ALERT SERVICE BULLETIN

TRANSMITTAL LETTER
FOR
SERVICE BULLETIN ANMD-32-20

**LANDING GEAR – TEMPORARY REVISION TO LANDING
GEAR UP WARNING HORN MICROSWITCH SETTING**

ANMD-32-20

Figure 1 – Engine Power Lever Aural Warning Microswitches

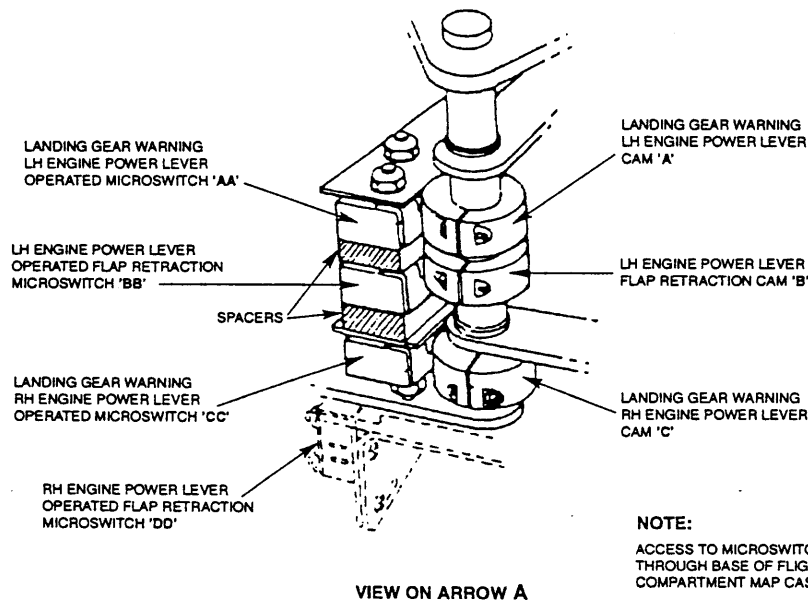
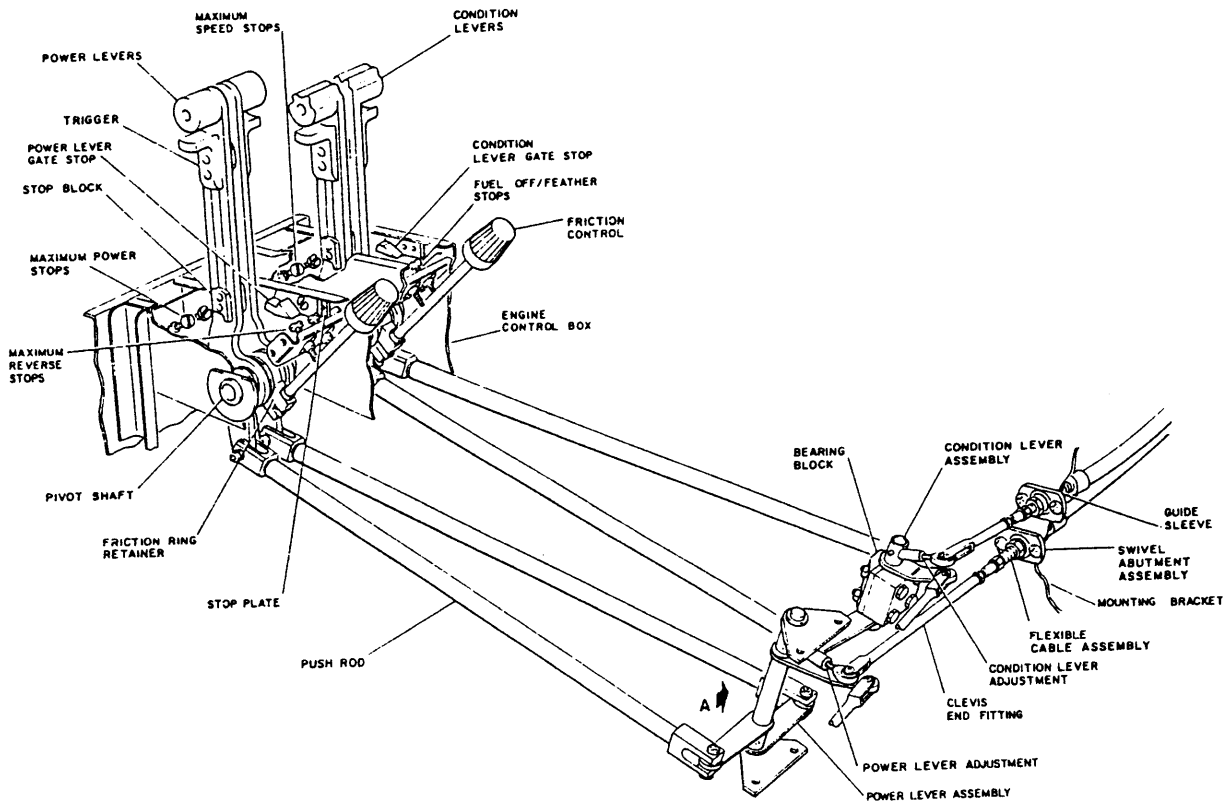
B. Part 2 – Adjustment of Engine Power Lever Actuated Landing Gear 'UP' Aural Warning Microswitches (Ref Fig 1)

- (3) Adjust the overtravel of the AA and CC microswitches to between 0.020in to 0.030in by loosening the nuts on the microswitch mounting rods and adjusting the microswitch position accordingly. Lock the mounting rod nuts when overtravel adjustment is complete.

- (6) Connect a continuity tester across terminals 'C' and 'NO' of top microswitch 'AA'.
- (7) Adjust cam 'A' by loosening the two locking screws on the cam and rotating the cam to operate microswitch 'AA'. Tighten the locking screws after adjustment.

- (8) Connect the continuity tester across terminals 'C' and 'NC' of bottom microswitch 'CC'.
- (9) Adjust cam 'C' by loosening the two locking screws on the cam and rotating the cam to release microswitch 'CC'. Tighten the locking screws after adjustment.
